European Window Film Association (EWFA)
Draft Supplement to Regulation No. 43

Annex 17 - Film applied to glazing on the inside

Film applied to glazing on the inside at positions which are not essential for driver’s vision

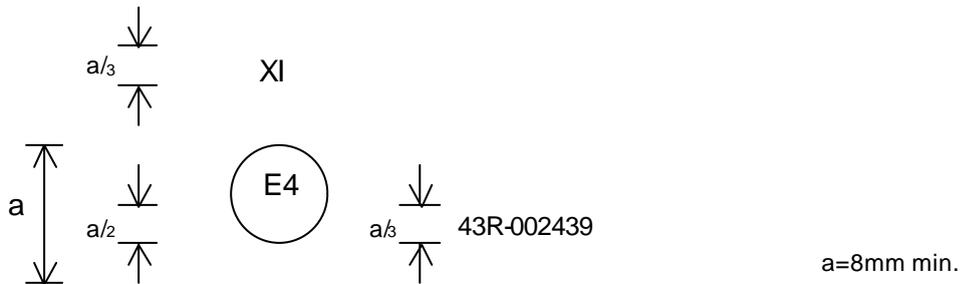
In addition, add at the end of this annex a new example of approval mark, to read:

The above approval mark affixed to a film applied to a glazing pane on the inside at positions that are not essential for driver's vision shows that the component concerned has been approved in the Netherlands (E4) pursuant to Regulation No. 43 under No. 002439. The approval number indicates that the approval was granted in accordance with the requirements of Regulation No. 43.
